ROAD SAFETY AUDIT

EXISTING ROAD

Lismore Railway Viaducts at:

- Union Street, South Lismore
- Terania Street, North Lismore
- Winterton Parade, North Lismore
- Alexandra Parade, North Lismore

Photo 17: Inadequate definition of curve alignment – southbound approach to Winterton Parade viaduct

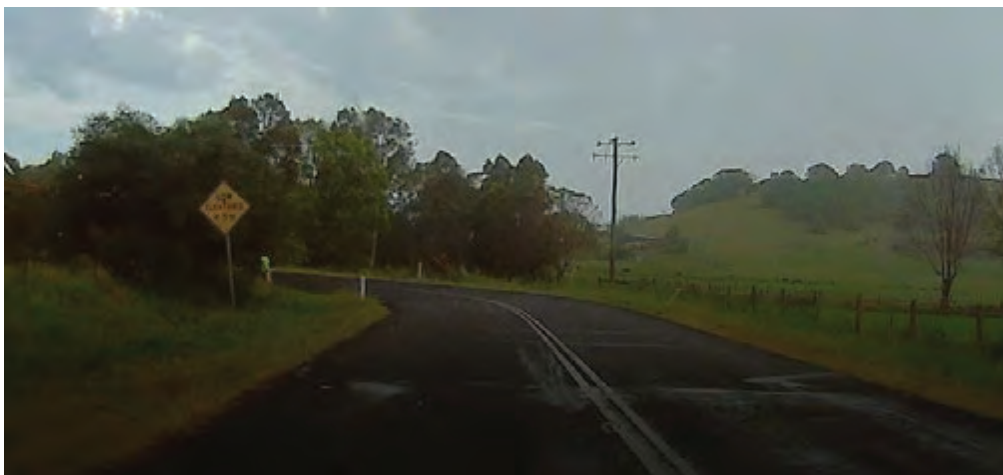
<p>21</p>	<p>Edge Clearances</p> <p>There is minimal clearance from edge of the road carriageway to the pylons.</p> <p>There is a risk that a vehicle could collide with a viaduct pylon.</p> <p><i>Refer to Photo 15</i></p>	<p>Likelihood: Possible</p> <p>Severity: Serious</p> <p>Risk: High</p>
<p>22</p>	<p>No Advance Warning Signs or Advisory Speed for the 90° Bends in Approaches</p> <p>There are no advance warning signs or advisory speed signs for the bends (both approaches).</p> <p>Without adequate advance warning and advice, there is a risk that motorists will not correctly anticipate the road’s alignment, particularly at night, resulting in a collision with an oncoming vehicle, a roadside hazard, or a viaduct pylon.</p>	<p>Likelihood: Possible</p> <p>Severity: Serious</p> <p>Risk: High</p>
<p>23</p>	<p>Inadequate Definition of Curve Alignments</p> <p>There are some alignment delineation devices on the southern bend, none on the northern bend. The devices on the southern bend are obscured by vegetation (northbound) and the viaduct pylons (southbound). These alignments could be considered hazardous without adequate delineation devices.</p> <p>Without adequate delineation, there is a risk that motorists may not correctly anticipate the road’s alignment, particularly at night, resulting in a collision with an oncoming vehicle, a roadside hazard, or a viaduct pylon.</p> <p><i>Refer to Photo 16, 17</i></p>	<p>Likelihood: Possible</p> <p>Severity: Serious</p> <p>Risk: High</p>

- At the Winterton Parade viaduct:
 - Provide advance warning signs and advisory speeds for the 90^o bends in the approaches to the viaduct.
 - Assess warrants for the provision of curve delineation devices on the 90^o bends in Winterton Parade, such as CAMs and guideposts. Provide additional devices as warranted. RRPM's may also be warranted to delineate bends and intersections at night.

Photo 24: Night visibility - southbound approach to Winterton Parade viaduct

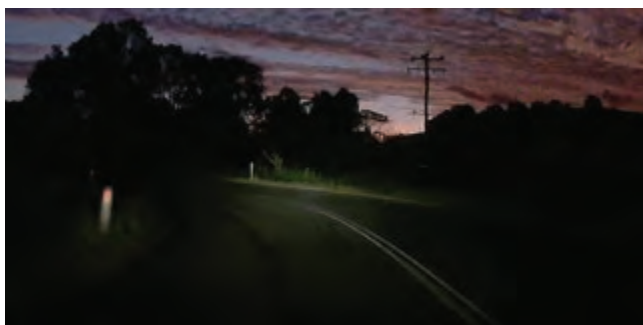
<p>30</p>	<p>Night Visibility of Bends and Viaduct</p> <p>The bends and the viaduct are poorly delineated at night. The line marking, guideposts, and delineation are inadequate. There are no RRPM's.</p> <p>Without adequate delineation, particularly at night, there is the potential for a crash on the bends or at the viaduct.</p> <p><i>Refer to Photo 24</i></p>	<p>Likelihood: Rare</p> <p>Severity: Serious</p> <p>Risk: Medium</p>
